ENGINEERING CHANGE NOTICE NO.

05397

DWG NO. 647.7700

DWG TITLE: STRUT ASSY

SHEET 2, ZONE D4 IS:

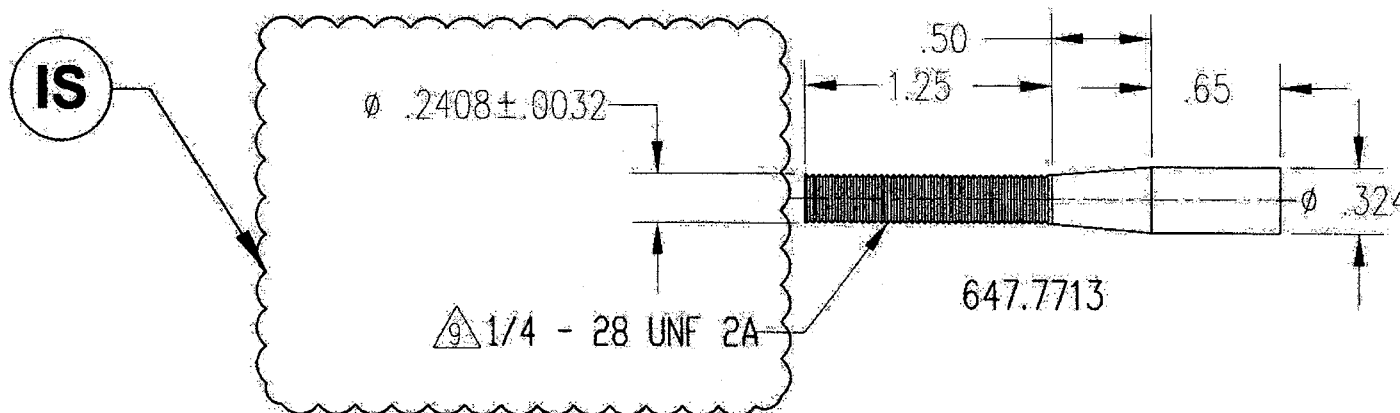
REASON: REVISED DIMENSION

SHEET 1, NOTES IS:

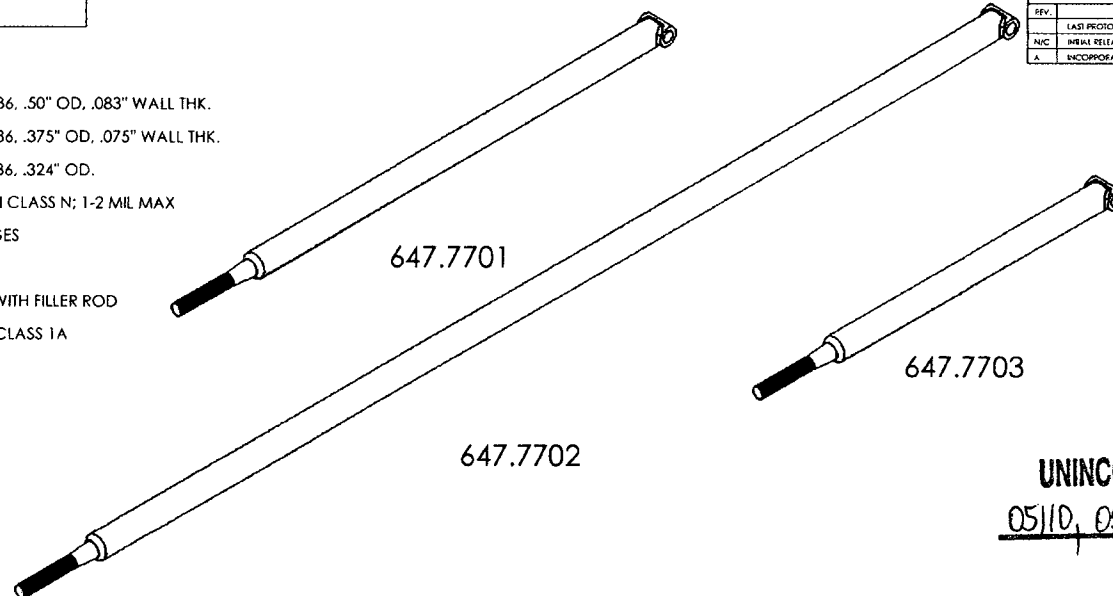
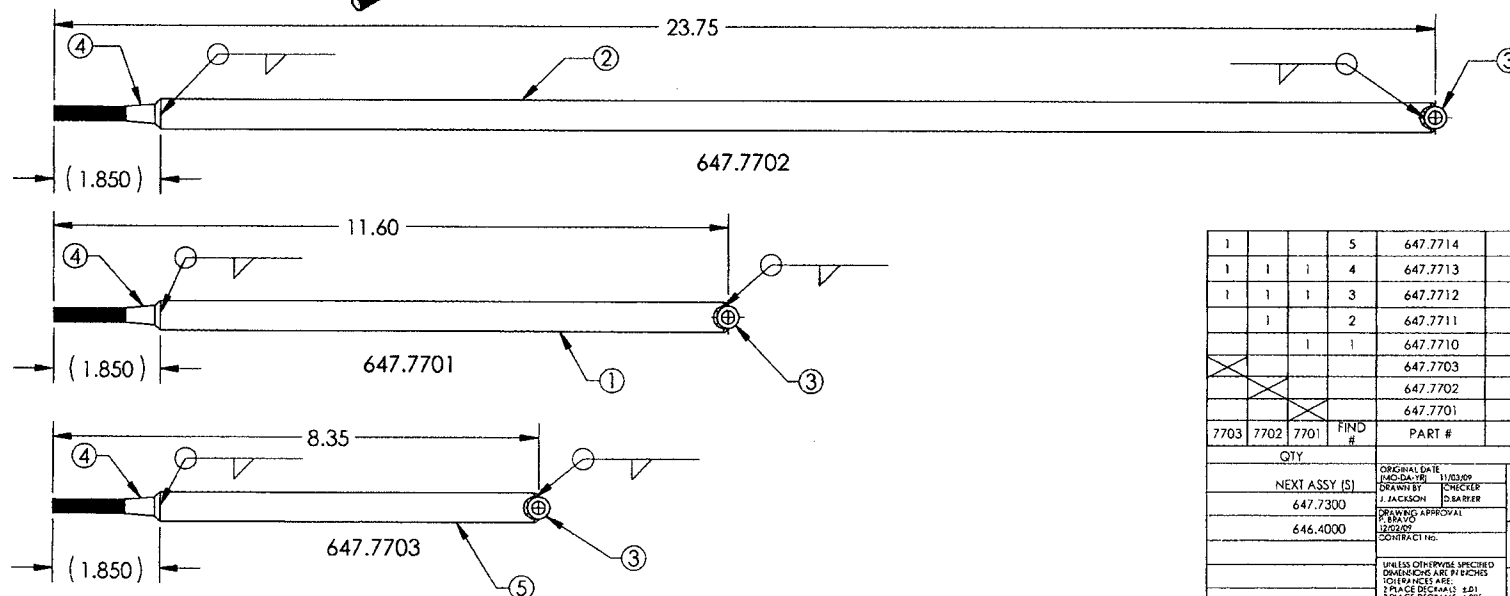
REASON: REVISED FINISH CALLOUT AS PER ECR 15-209

- 1 MATERIAL: 4130 STEEL PER AMS-T-6736 .50" OD. .083" WALL THK.
- 2 MATERIAL: 4130 STEEL PER AMS-T-6736 .375" OD. .075" WALL THK.
- 3 MATERIAL: 4130 STEEL PER AMS-T-6736 .324" OD.
- 4 FINISH: PRIME IAW MIL-P-2337J TYPE I CLASS N; 1-2 MIL MAX
5. DEBURR AND BREAK ALL SHARP EDGES
6. IDENTIFY IAW MPP-120.
- 7 WELD IAW MIL-STD-2219. TIG WELD WITH FILLER ROD
- 8 FINISH: CAD PLATE IAW QQ-P-416F CLASS I TYPE II
- 9 MASK THREAD PRIOR TO FINISH

- 1 MATERIAL: 4130 STEEL PER AMS-T-6736, .50" OD, .083" WALL THK.
- 2 MATERIAL: 4130 STEEL PER AMS-T-6736, .375" OD, .075" WALL THK.
- 3 MATERIAL: 4130 STEEL PER AMS-T-6736, .324" OD.
- 4 FINISH: PRIME IAW MIL-P-2337J TYPE I CLASS N; 1-2 MIL MAX
- 5 DEBURR AND BREAK ALL SHARP EDGES
- 6 IDENTIFY IAW MPP-120.
- 7 WELD IAW MIL-STD-2219. TIG WELD WITH FILLER ROD
- 8 FINISH: CAD PLATE IAW MIL-C-5541 CLASS 1A
- 9 MASK THREAD PRIOR TO FINISH
